Burlington High School Accessibility Survey

July 30, 2021

Prepared for:
CBI Consulting
250 Dorchester Avenue
Boston, MA 02127

Prepared By:
Code Red Consultants
154 Turnpike Road, Suite 200
Southborough, MA 01772

FIGURE 8: STAIR DEFICIENCIES

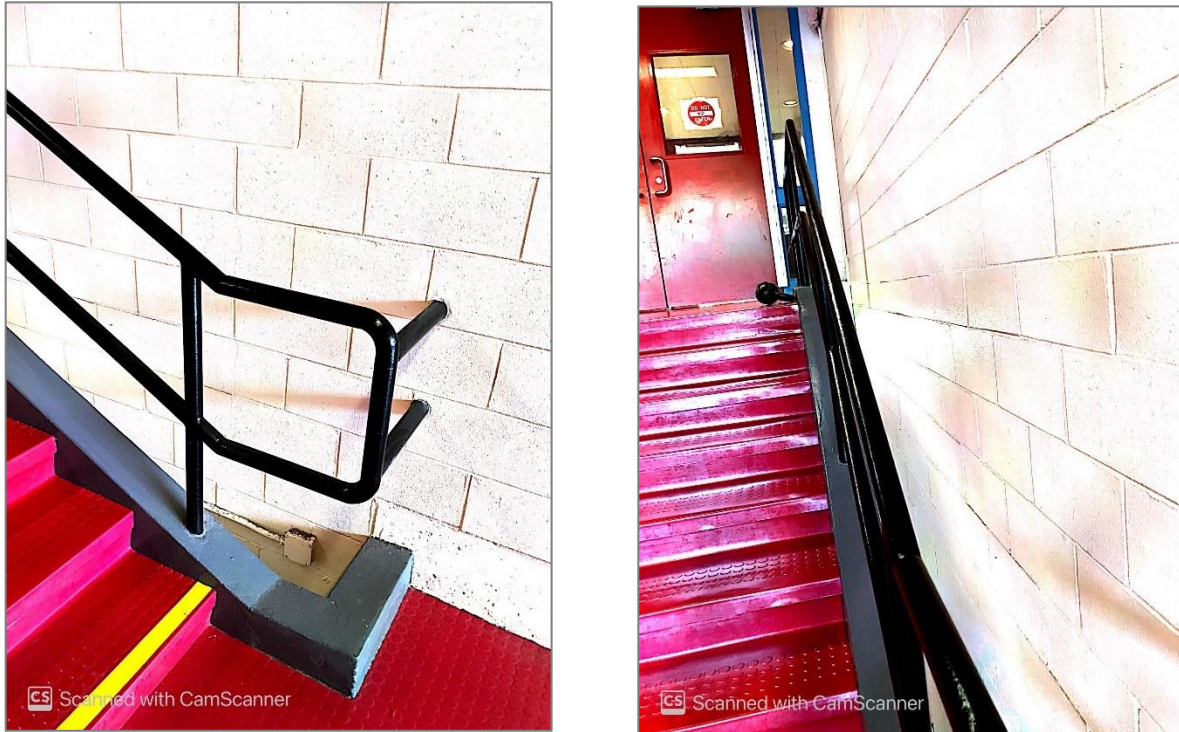
Stairs are required to comply with 521 CMR Chapter 27.00. Generally, the stairs are noncompliant. The following requirements were noted as noncompliant:

- Stair tread depth and riser height, required to comply with 521 CMR 27.2, are generally noncompliant as they are not uniform.
- Handrails, required to comply with 521 CMR Chapter 27.4, are generally noncompliant as they are not provided in some locations or have insufficient extensions. Handrails are also required to have a clear space of 1.5" between the handrail and adjacent side wall, which typically did not comply.

FIGURE 10: CHOIR ROOM & LECTURE HALL

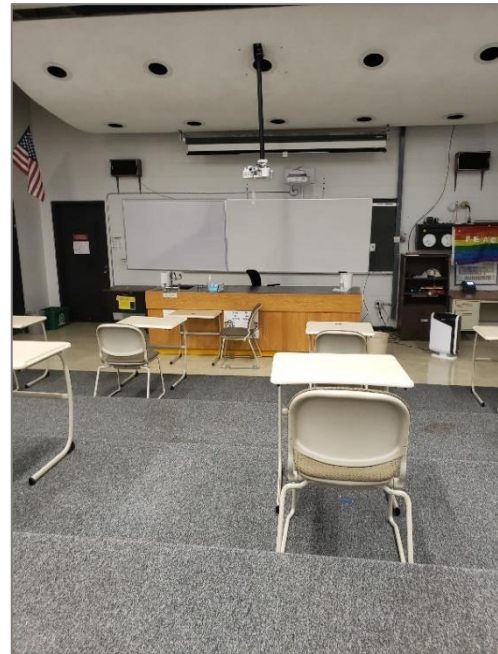
The choir room, band room, and lecture hall all on the First Floor, as shown in Appendix A, contain tiered floors. The rooms do not provide an accessible route to the performing areas of the band room and choir room. Based on the length of the tiers in the band and choir rooms, there is potential for the room to accommodate more than 150 people, requiring accessible seating to be dispersed. Within the lecture hall, there are provided desks, none of which are accessible. Additionally, an assistive listening system was not observed for any of these rooms in accordance with 521 CMR 14.5.1. Specific deficiencies associated with these rooms are noted in the Appendices.

Alleviating these deficiencies would include studying an accessible route to the bottom of the tiers either via a ramp per 521 CMR 24.00 or lift per 521 CMR 28.00, installing an assistive listening system for assembly spaces in accordance with 521 CMR 14.5, and providing accessible seating options. If the choir and band room are fixed at 150 or less, the accessible seating would be permitted to be in one location rather than dispersed.

FIGURE 11: AUDITORIUM

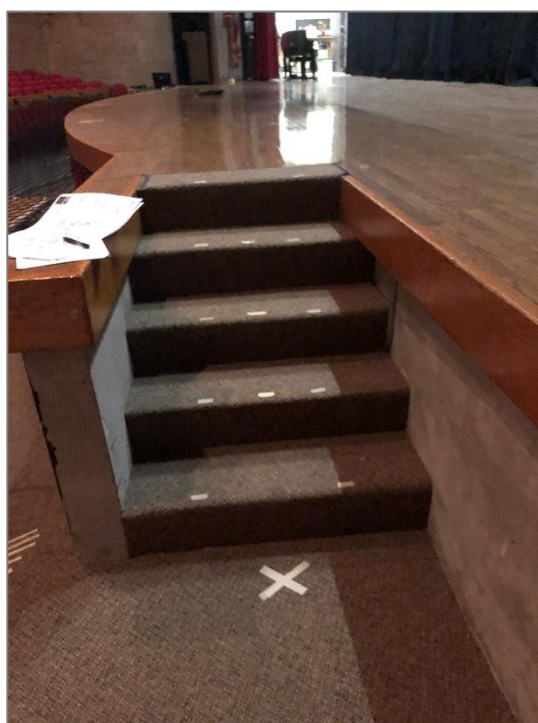
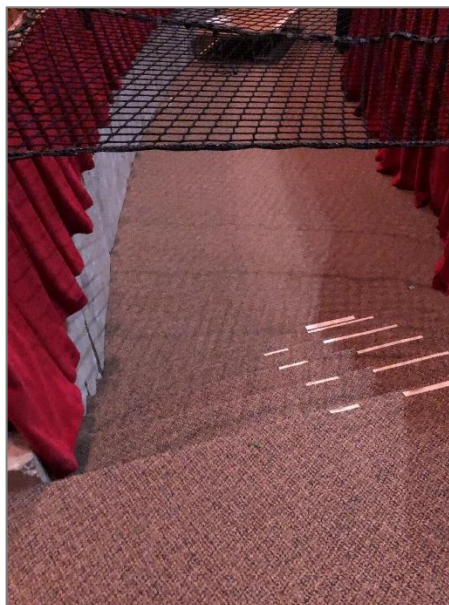
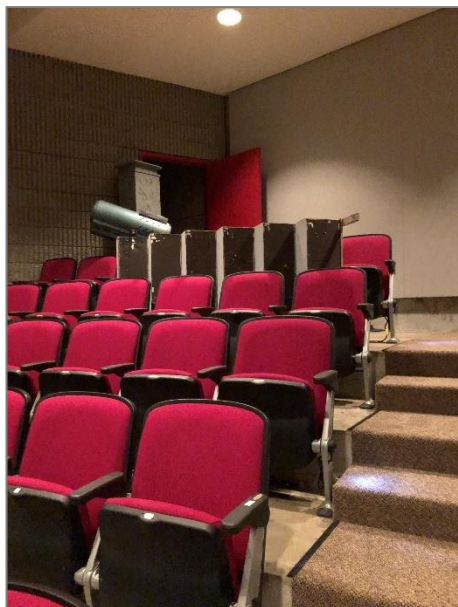
No accessible seating is provided for the space. Based on the 789 fixed seats that were observed, a total of 9 accessible spaces complying with 521 CMR 14.4 would be required (521 CMR 14.2).

The accessible route throughout the space is noncompliant. There is no accessible route to the orchestra pit, stage, sound booth, or upper section of seating. Where stairs are provided to these spaces, they are not provided with handrails on both sides. In addition, the ramps provided down the aisles of the lower seating exceeded the maximum permitted slope of 8.3% by almost double. It should be studied whether a compliant set of ramps can be installed, noting that ramps are limited to a 30 foot run before a compliant landing is required. A lift to access these areas should also be considered.

FIGURE 12: CAFETERIA SEATING

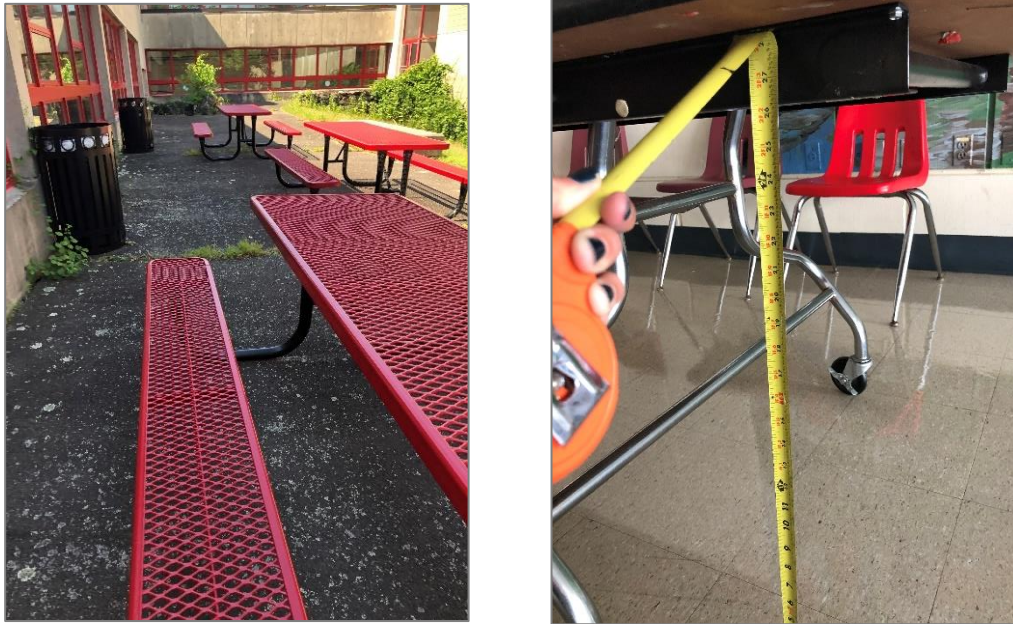
The school's cafeteria is located on the First Floor, as shown in Appendix A. No accessible route or accessible seating is provided in the outdoor dining area. Additionally, none of the indoor seating is compliant as it does not provide adequate knee clearance. Specific deficiencies are noted in the Appendices.

FIGURE 16: LOCKER ROOM DEFICIENCIES

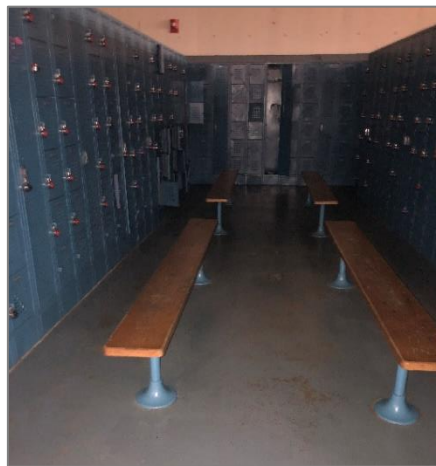
- No accessible restroom stalls or showers are provided which is required by 521 CMR 30.1 and 31.1. Additionally, urinals and sinks were observed to be noncompliant.
- The aisle between benches and lockers is less than 36". There must be an aisle at least 36" wide according to 521 CMR 19.4.2.

FIGURE 18: TYPICAL ROOM SIGNAGE

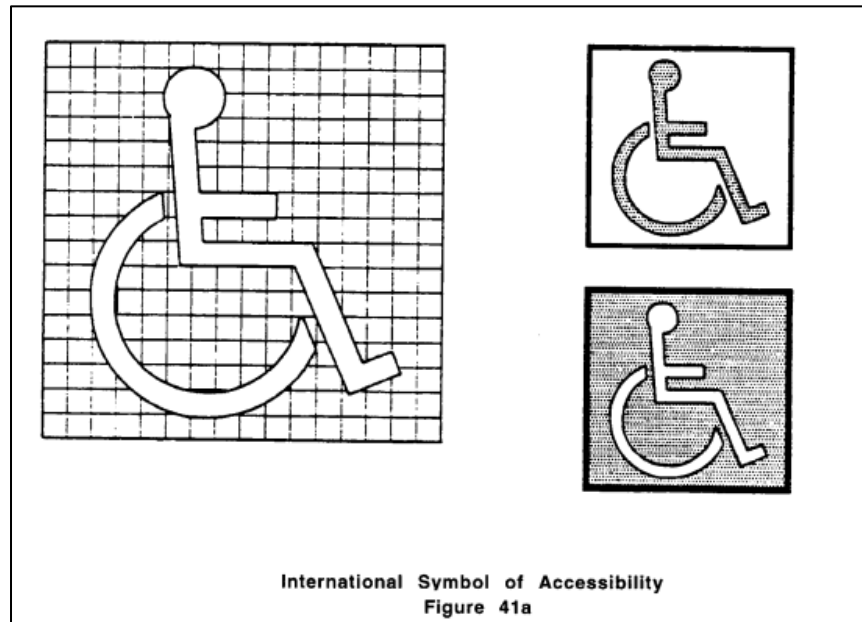
- Tactile room signage and directional signage is required at the locations specified by 521 CMR Chapter 41.1 and all permanent rooms and spaces (521 CMR 41.00).
 - Room names/numbers
 - Toilet rooms
 - Stair signs
 - Designated accessible parking spaces
 - Accessible passenger loading zones
 - Emergency egress signs, which are required to be illuminated (including international symbol of accessibility)
- Signage is required to be provided at any entrance/exit of the building not accessible by persons in a wheelchair to clearly indicate the location of the accessible entrance/exit is (521 CMR 25.6).

Additionally, elements and spaces of accessible facilities including emergency egress signs are required to be provided with the International Sign of Accessibility. None of the exit signs within the building were provided with this signage.
